URGENT: FIELD SAFETY NOTICE

Medima Infusion Pump

9th January 2025

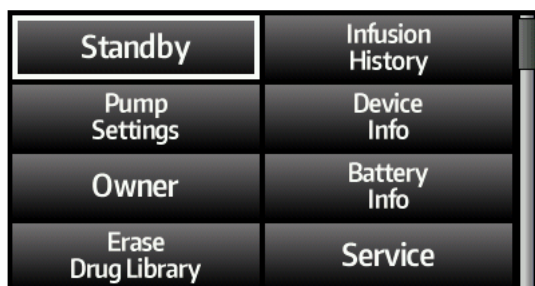
If you use software version 3.1.87 and older, do not use dosing units of mL/min or mL/24h with the “Profile” infusion mode and refrain from making dose rate changes when this mode is selected.

In “**Profile**” infusion mode, please use only **ml/h** units until you update your software version to 3.1.88 or above.
